DeYOUNG SUBDIVISION Construction Drawings El Paso County, Colorado

EPC STORMWATER REVIEW COMMENTS ARE SHOWN IN ORANGE BOXES WITH BLACK TEXT

PCD-ENGINEERING REVIEW COMMENTS IN BLUE BOXES WITH BLUE TEXT

PCD PROJECT NO. MS-20-001

PHASE 1 - SITE GRADING & EROSION CONTROL PLAN

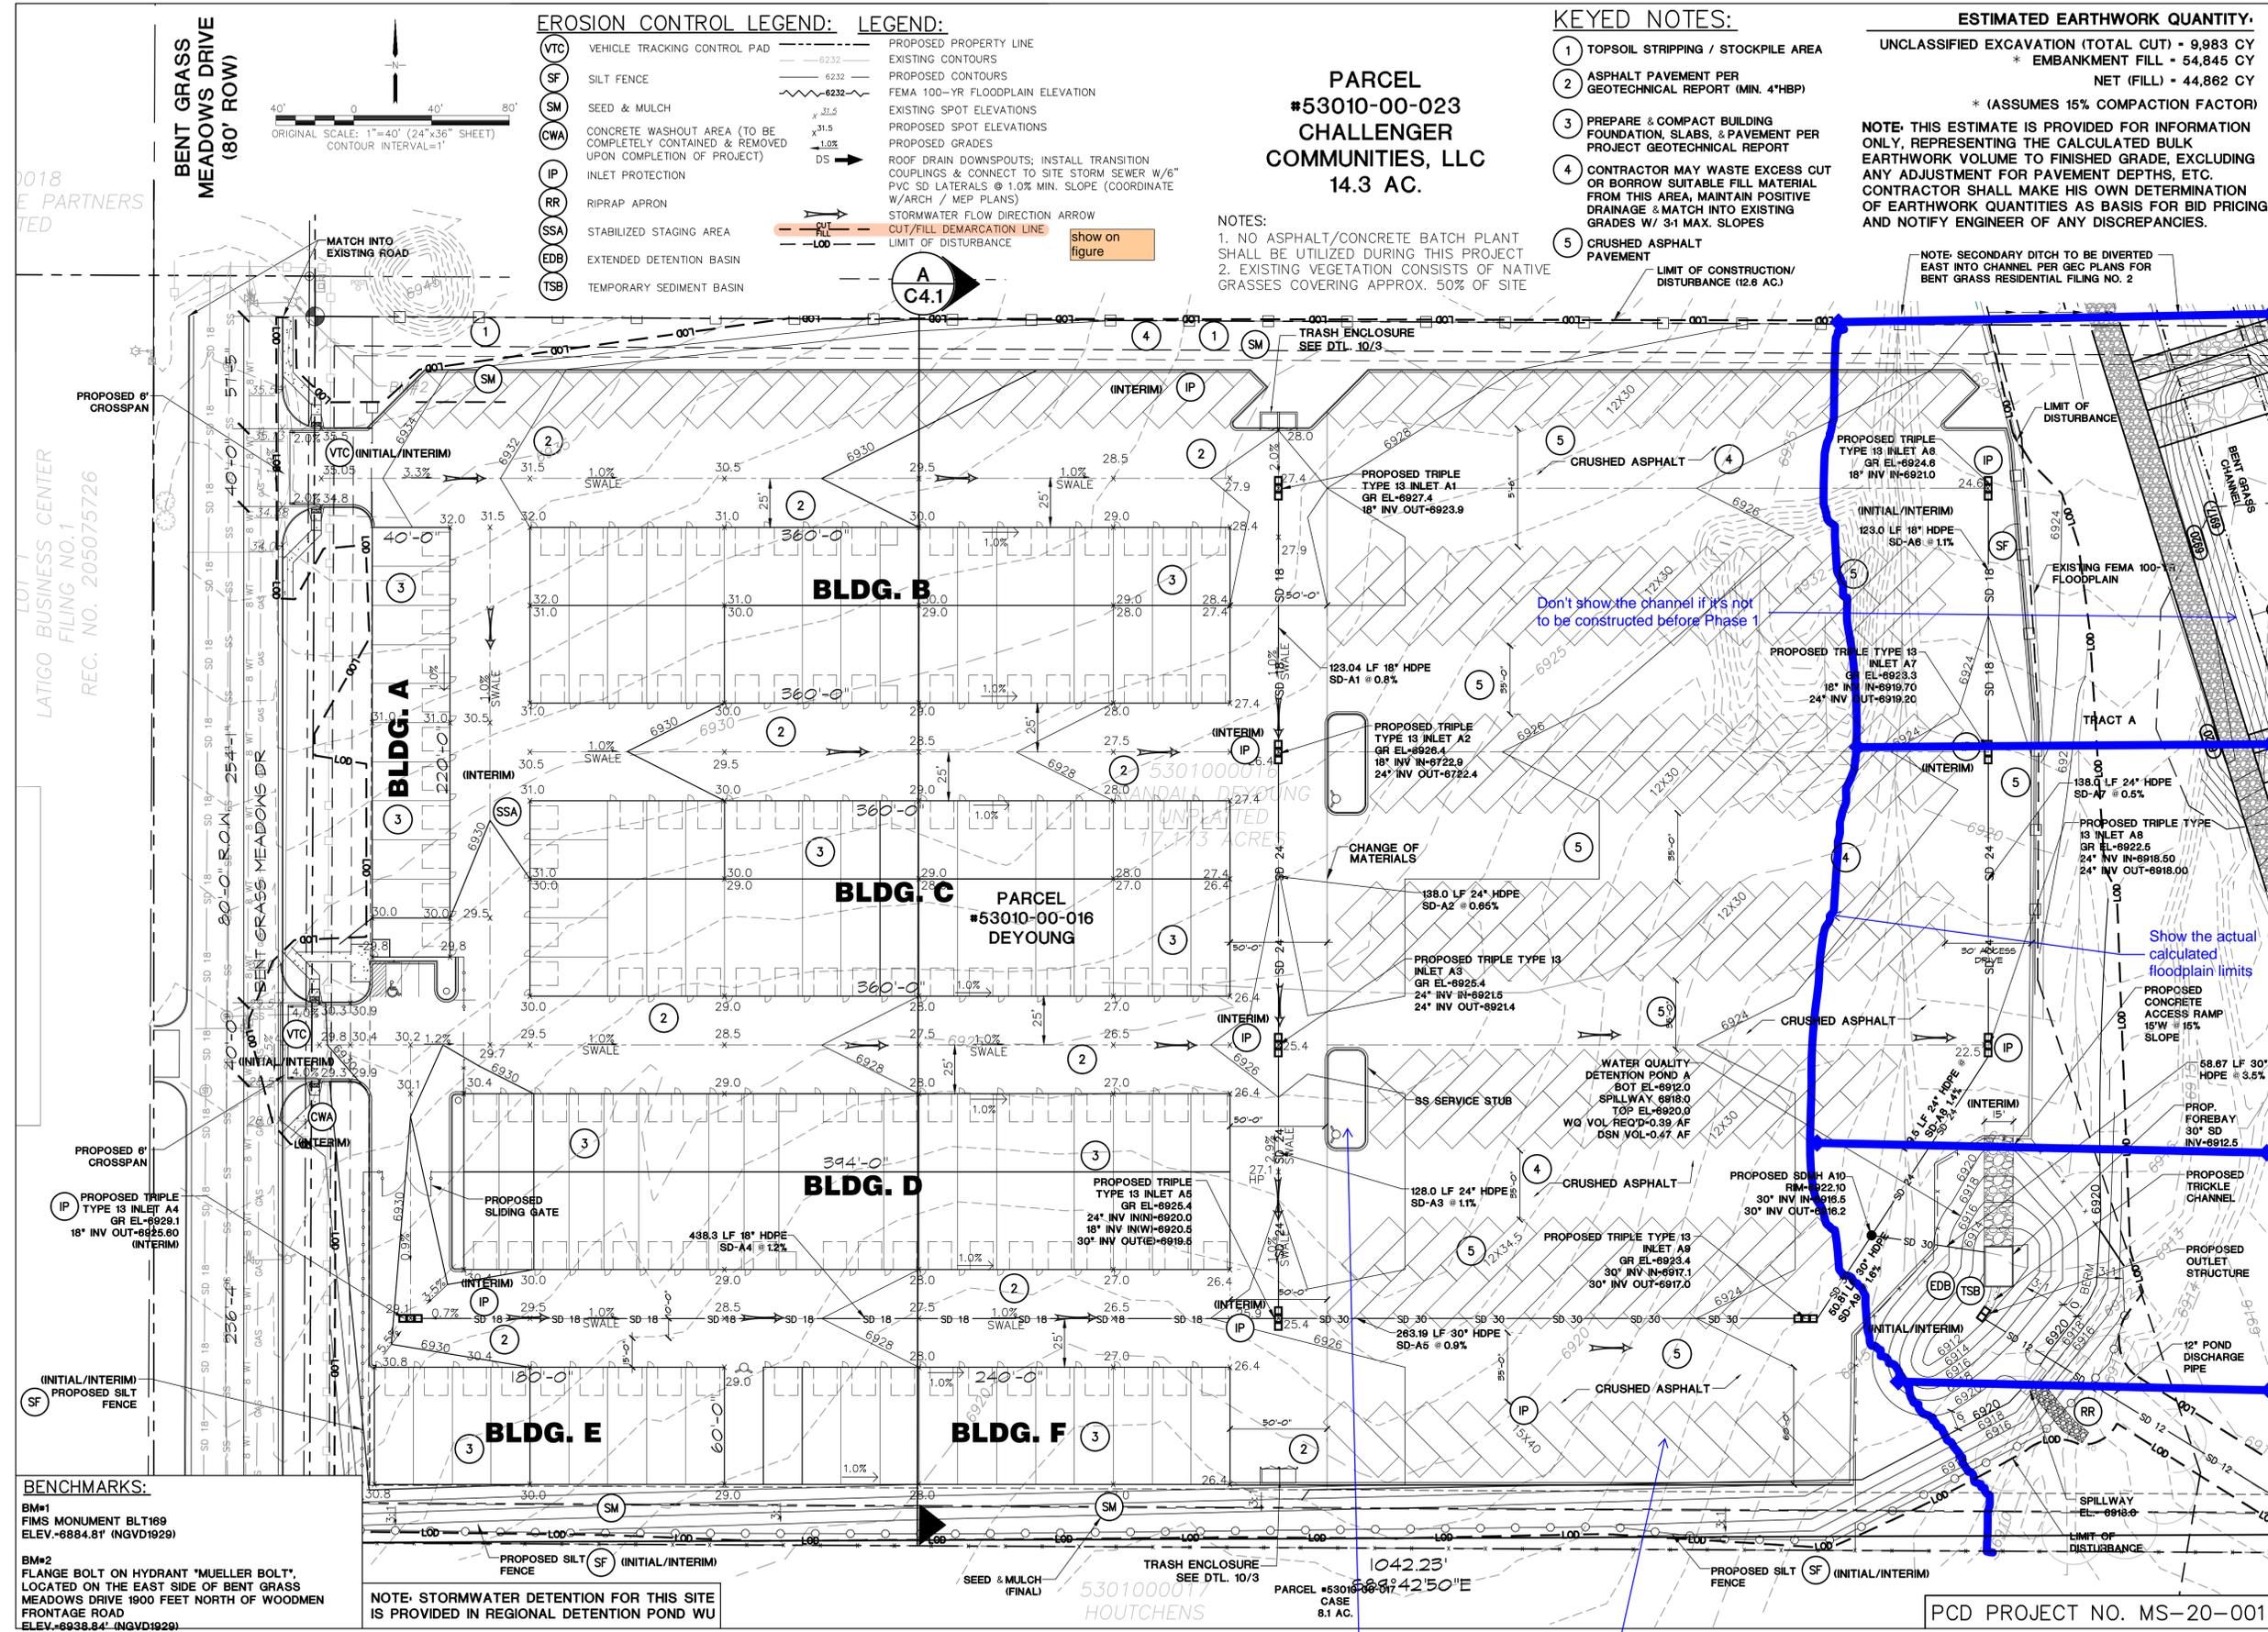
Is this a raised island?
Don't show parking spaces

DETECTION POND PLAN
SCALE: 1"=20'

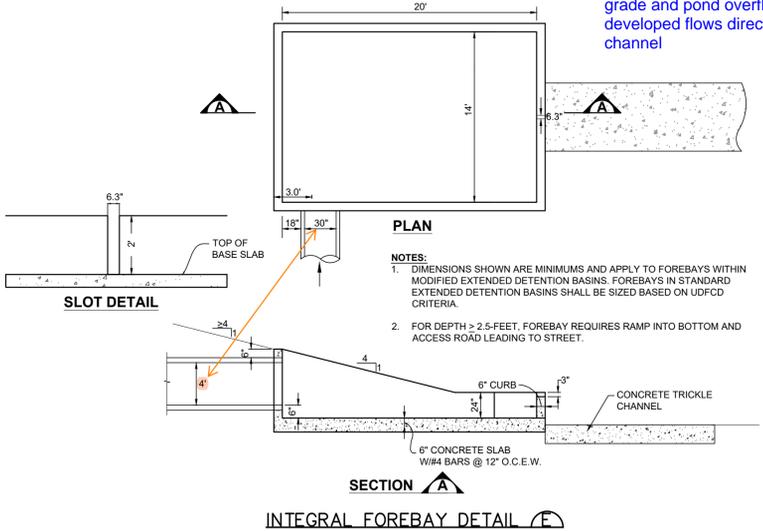
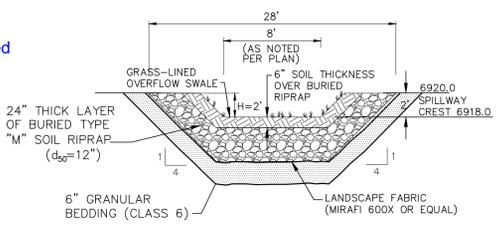
This area will need to be filled in for channel construction. Show proposed grade and pond overflow for developed flows directed to the channel
